THE STATE OF NEW HAMPSHIRE
DEPARTMENT OF TRANSPORTATION

RE: NHDES File Number: 2018-03134/ NHDOT Project # Derry-Londonderry 13065
Standard Dredge and Fill Wetlands Permit Application (RSA 482-A)
Interstate 93 Exit 4A Interchange Project, Derry and Londonderry, NH

The NH Department of Transportation (NHDOT) would like to request an amendment to the existing Wetlands and Non-Site Specific Permit 2018-03134 that was issued on May 5, 2020, to account for recent design modifications. The design changes associated with Shields Brook to accommodate the proposed future expansion of the Derry Rail Trail have prompted this permit amendment request. However, it is worth noting that the overall impacts for the Interstate 93 Exit 4A Interchange Project have been reduced from the previously permitted quantities. Please refer to the attached 13065B Wetland Impact Update Memorandum for detailed information regarding the design updates and impact modifications.

Project #: Derry-Londonderry 13065B
VHB #52768.00

STATE OF NEW HAMPSHIRE			
DEPARTMENT OF TRANSPORTATION * BUREAU OF BRIDGE DESIGN			
TOWN	DERRY	BRIDGE NO.	053/110
STATE PROJECT	13065B		
LOCATION	FOLSOM ROAD OVER SHIELDS BROOK

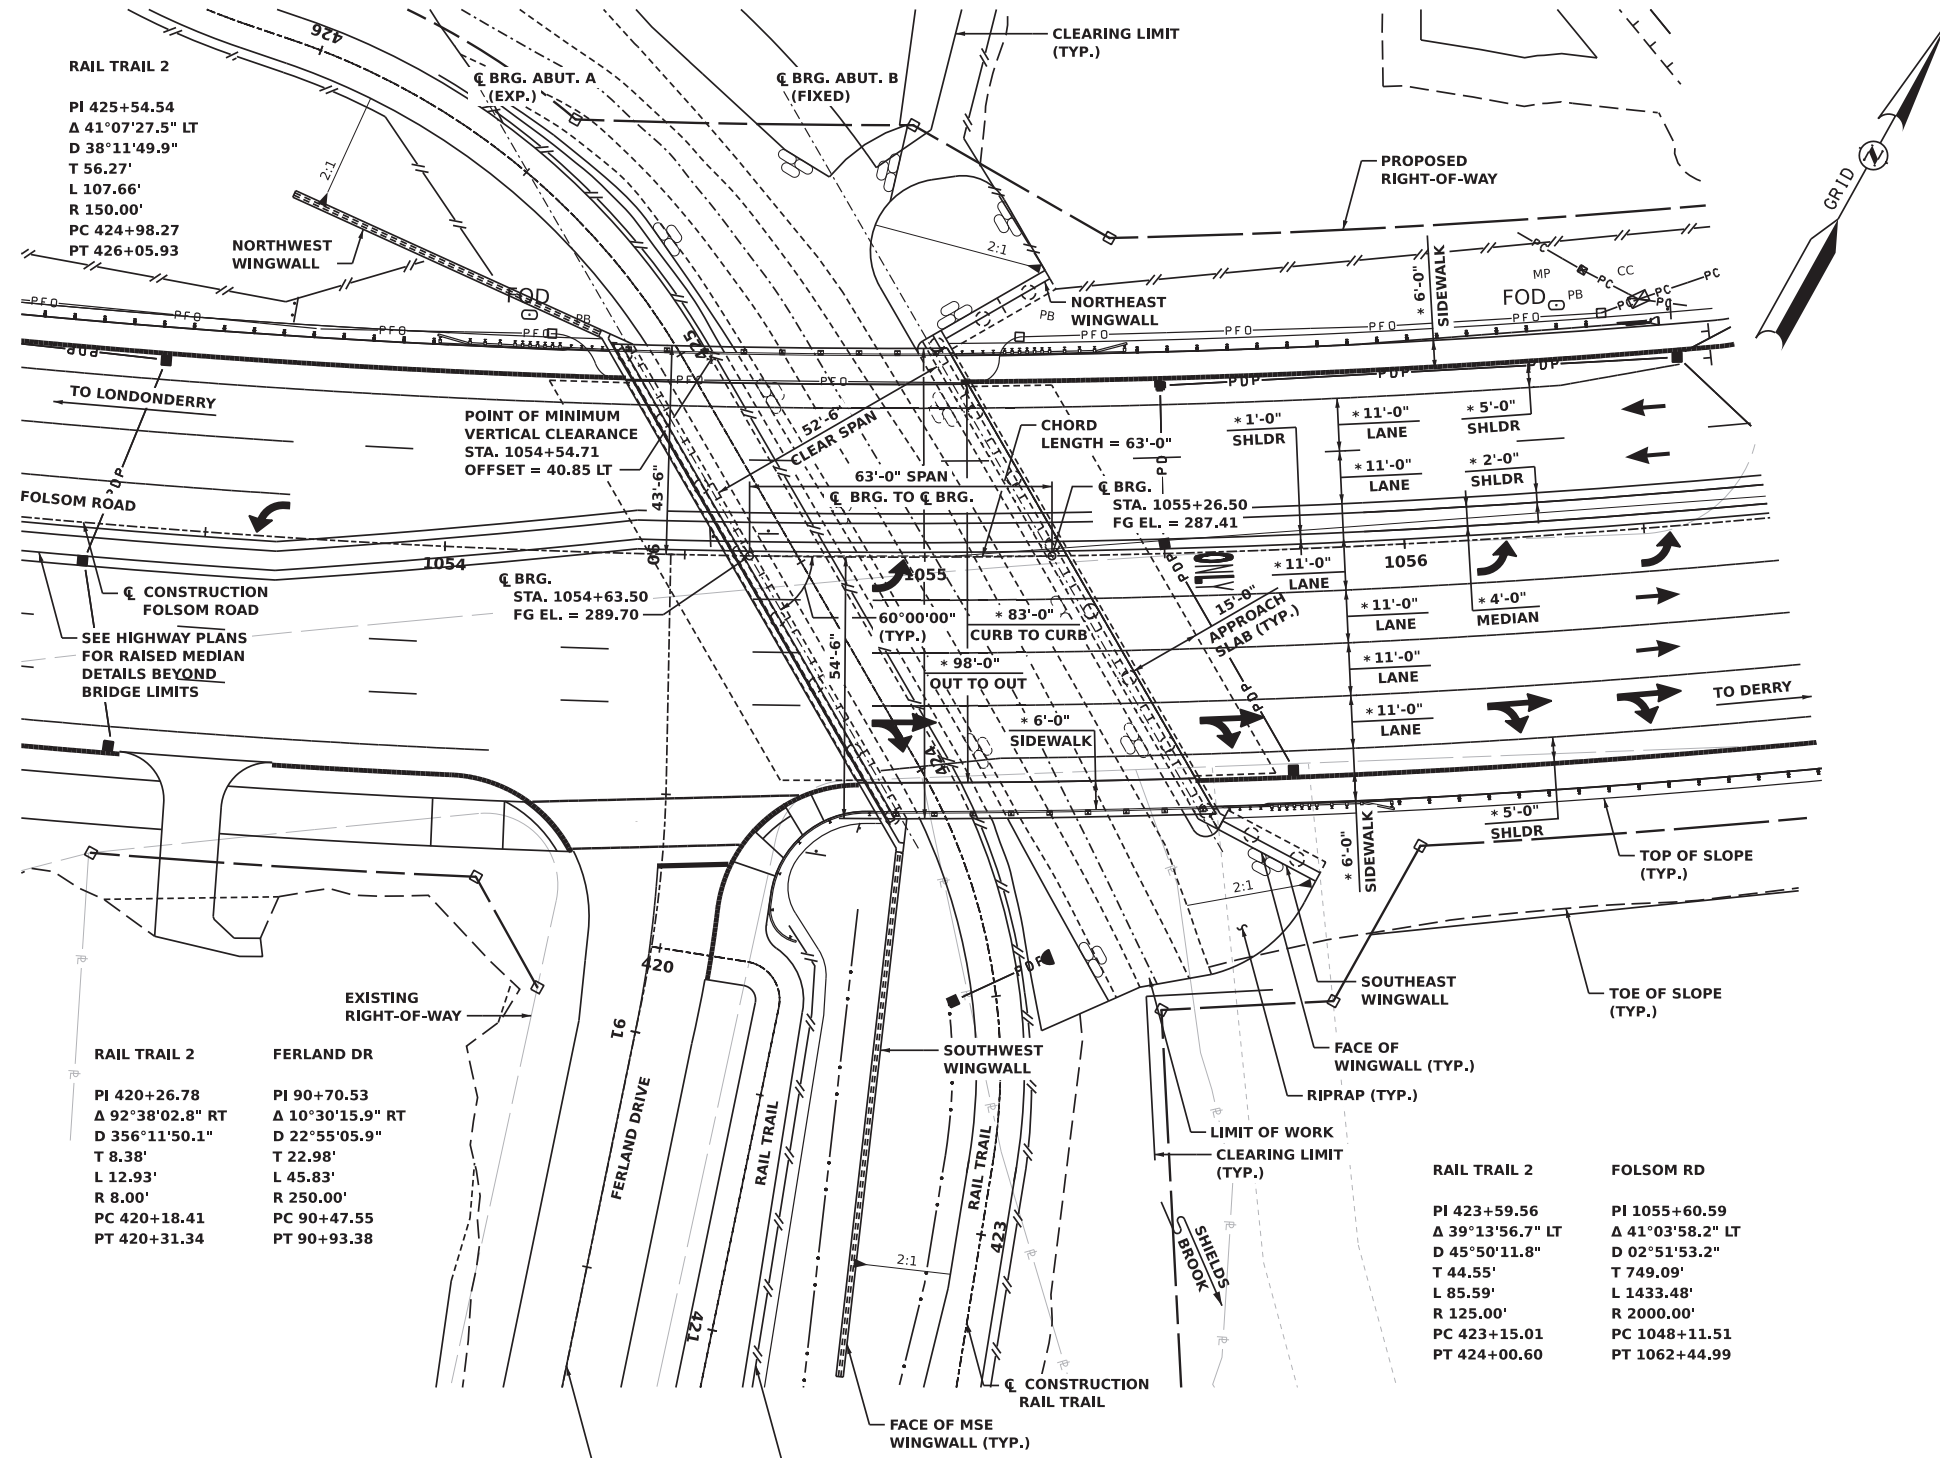
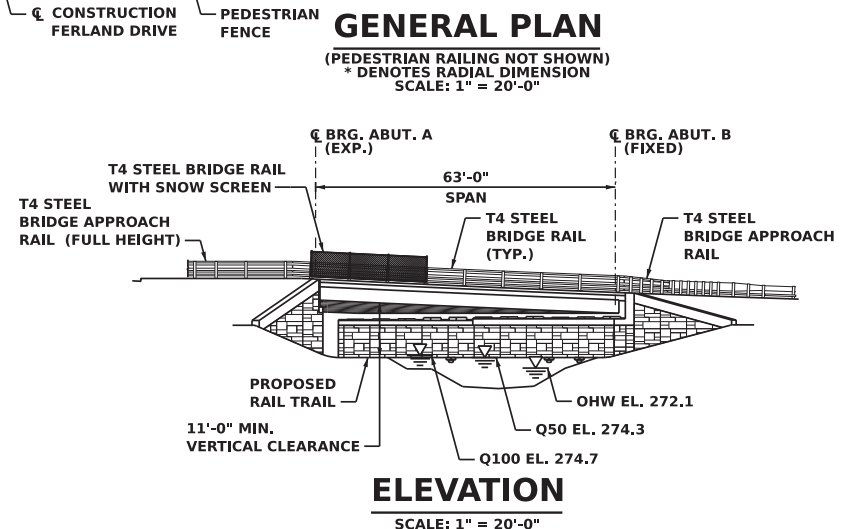
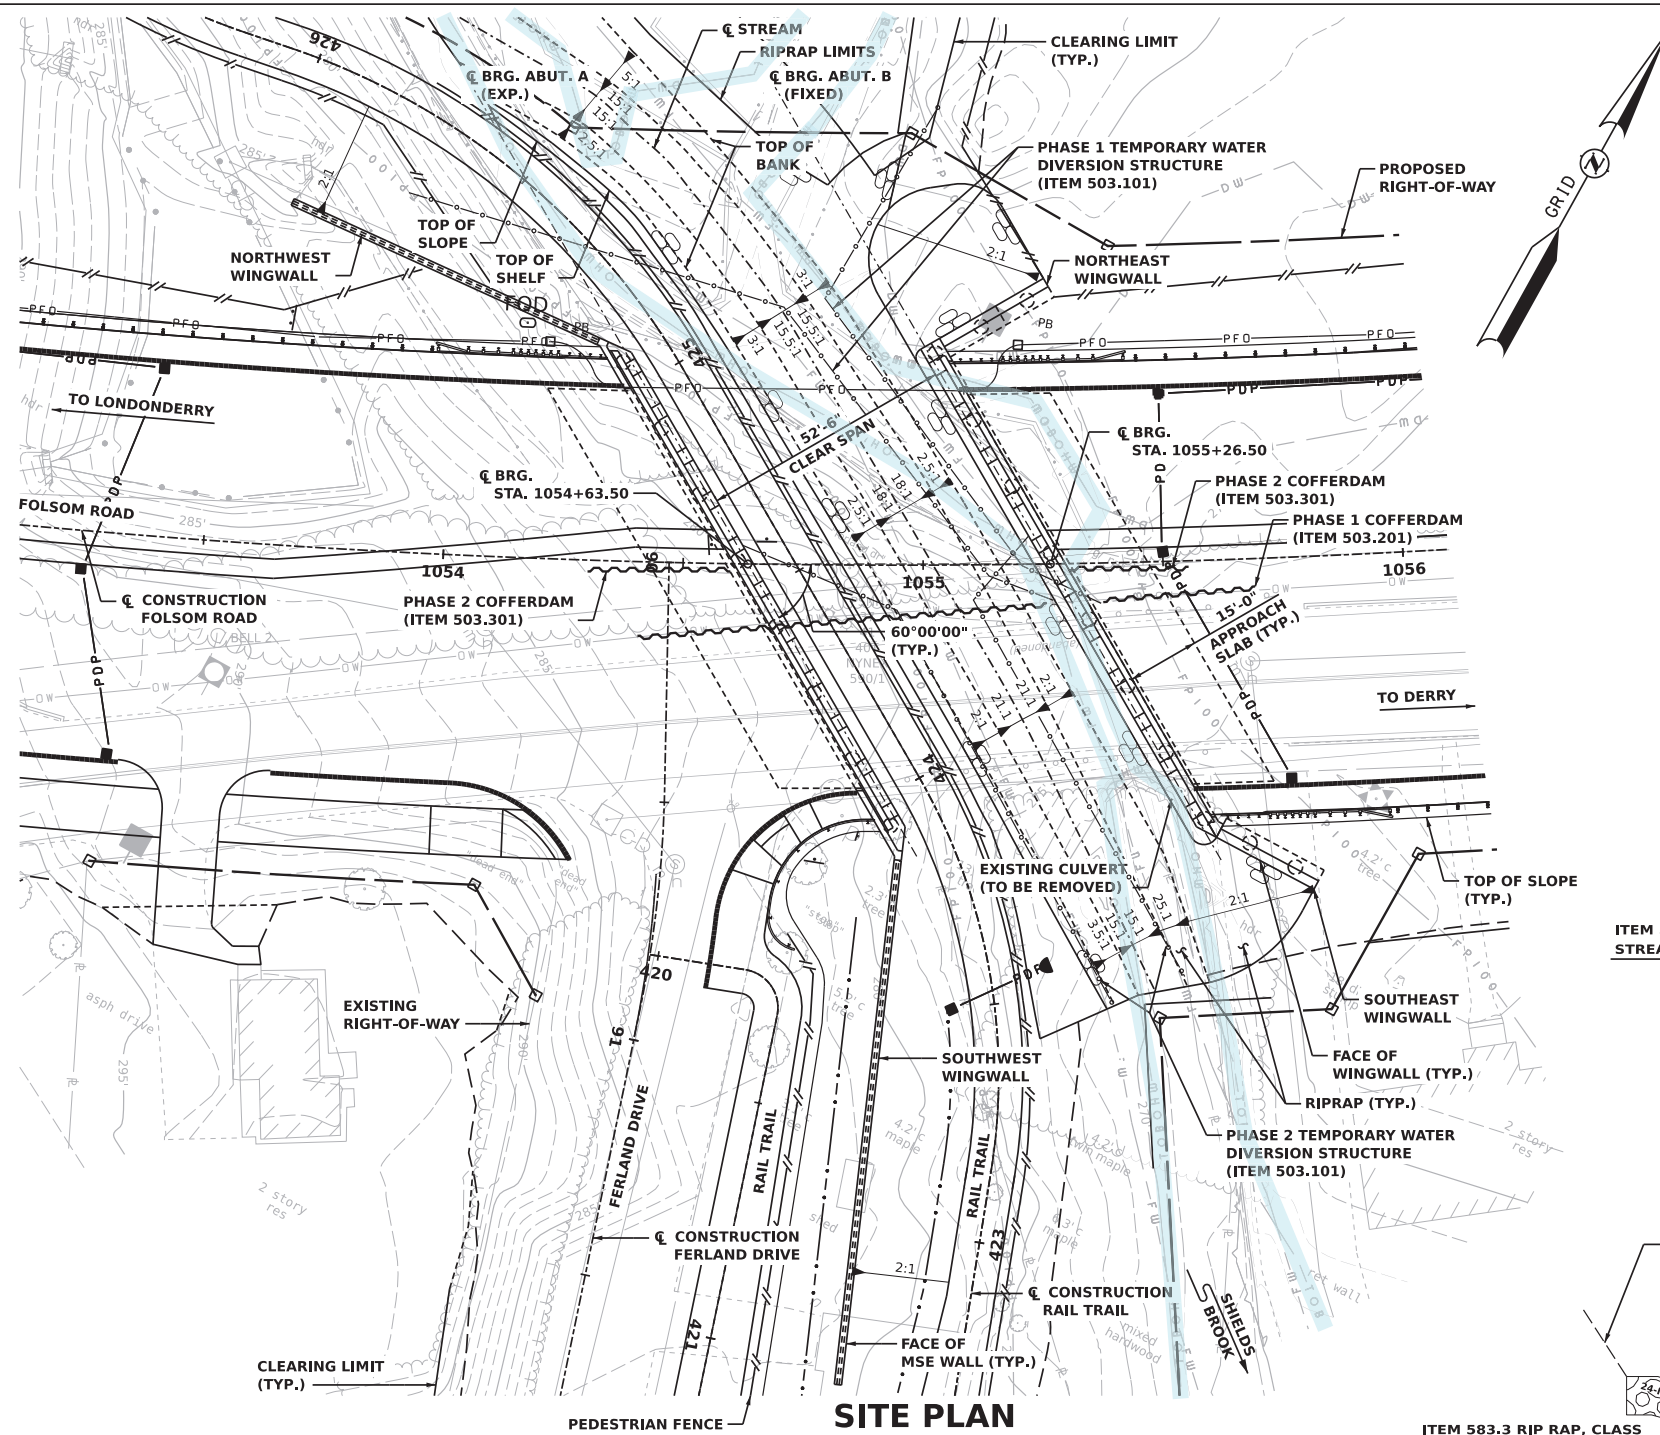
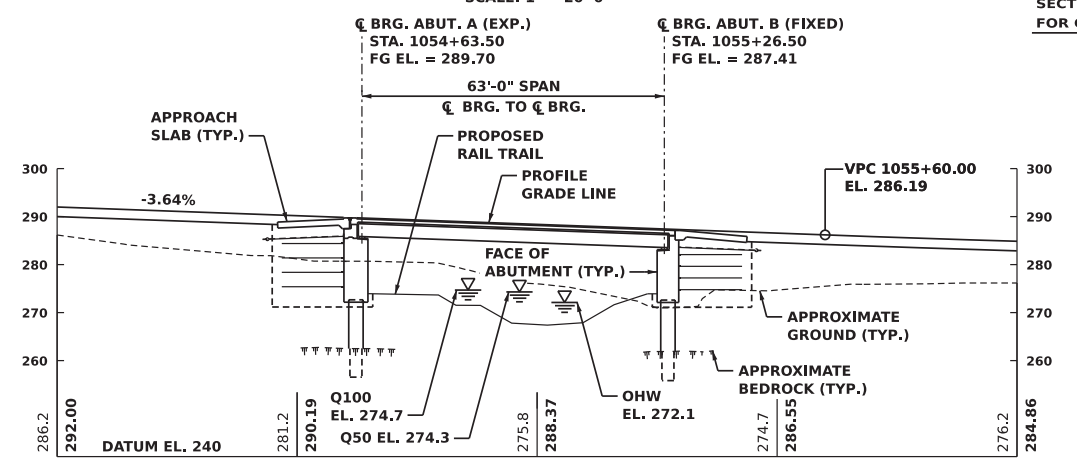
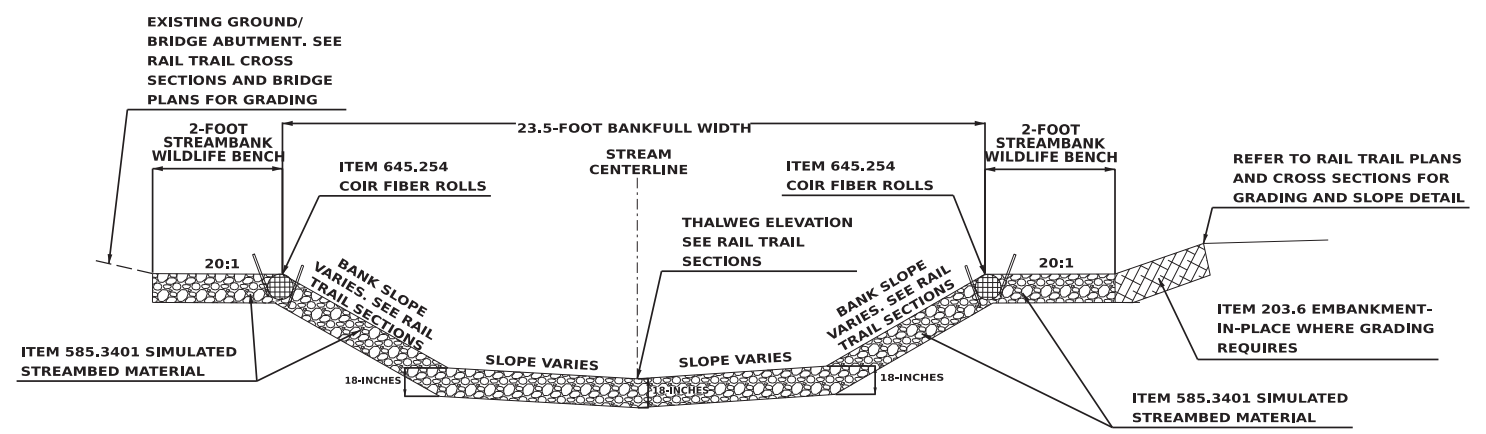
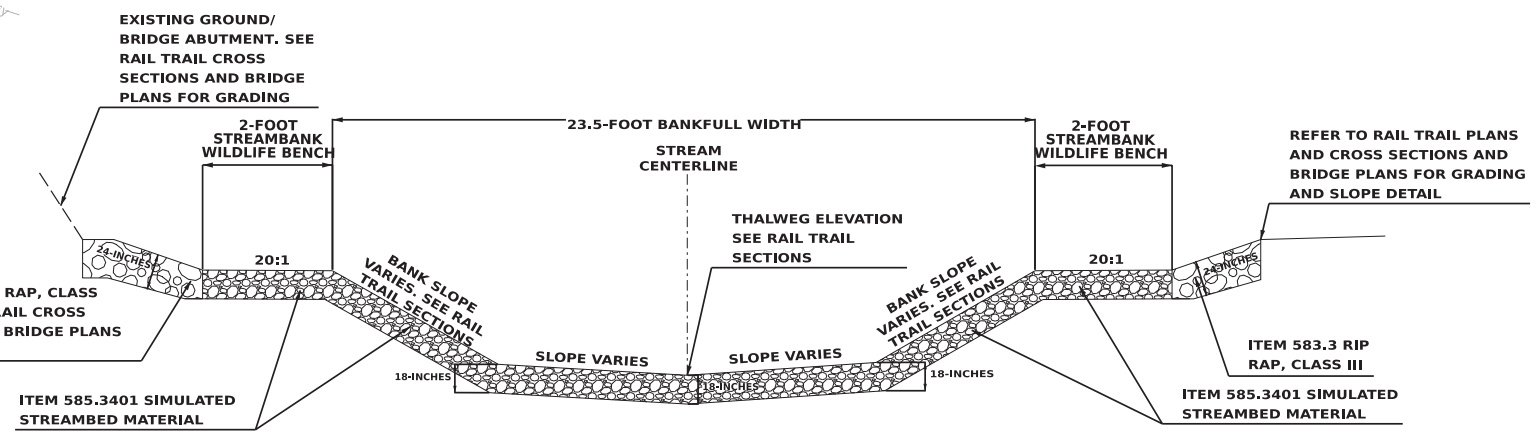
- › **Shields Brook & Wetland 41:** An update to the approved design of the Shields Brook crossing is proposed to accommodate the future expansion of the Derry Rail Trail. The proposed geomorphically incompatible crossing in this location will be replaced with a compatible crossing. Refer to **Section C** below for more information. This will result in additional impact to Shields Brook (also labeled as Stream 2 or S2 on the plans) and bordering W41 through permanent impacts BL, BM, BN, and BO and temporary impacts TAS, TAT, TAU, TAV, and TAW. The cumulative permanent impact increase is approximately 1,308 sq ft (119 lin ft) and the cumulative temporary impact increase is approximately 205 sq ft.

An update to the design of the Shields Brook crossing is proposed to accommodate the future expansion of the Derry Rail Trail and design changes to Folsom Road within the Exit 4A project area. Specifically, the NH Department of Transportation (NHDOT) proposes to provide a grade separated crossing of Folsom Road using Bridge 053/110 at Shields Brook (aka Beaver Brook), rather than providing a dedicated rail trail connector underpass as described in the February 2020 National Environmental Policy Act (NEPA) Final Environmental Impact Statement (FEIS)/Record of Decision (ROD) and permitted. Updated design plans for Shields Brook are provided as **Attachment F**.

(NHDES Administrative Rules Env-Wt 900, *Stream Crossings*). This review resulted in a proposal to replace the existing undersized crossing with a new bridge that would be much larger than the existing culvert. The current design includes a bridge carrying Folsom Road over Shields Brook (Bridge 053/110) with a clear span of 52.5 feet (60 feet skewed at 30 degrees) which meets both NHDOT hydraulic requirements and the NHDES Stream Crossing Guidelines. This larger bridge allows for the routing of the grade-separated path connection to the proposed Derry Rail Trail under the Shields Brook Bridge without increasing the span length. This stream is classified as Riverine, Upper Perennial, Unconsolidated Bottom, Mud (R3UB3).

The proposed channel design includes a 23.5-foot bank full width channel with a low flow 5-point cross section and overbanks that are 2 feet wide on river right and left for wildlife crossing. The overbanks are located approximately at the 2-year design storm elevation. In addition to the wildlife crossing, river right includes the 14-foot-wide path to the proposed Rail Trail located just above the predicted 100-year design storm elevation. The alignment of the path to the proposed Rail Trail upstream of the crossing has been modified from previous design iterations to improve safety and has shifted the path to the north towards Shields Brook. As a result, the alignment of Shields Brook had been modified to reflect this adjustment. This change adjusts the footprint illustrated on the approved plans. The proposed design predicts 9.0 feet and 8.1 feet of freeboard during the 100-year and 500-year design storms, respectively.
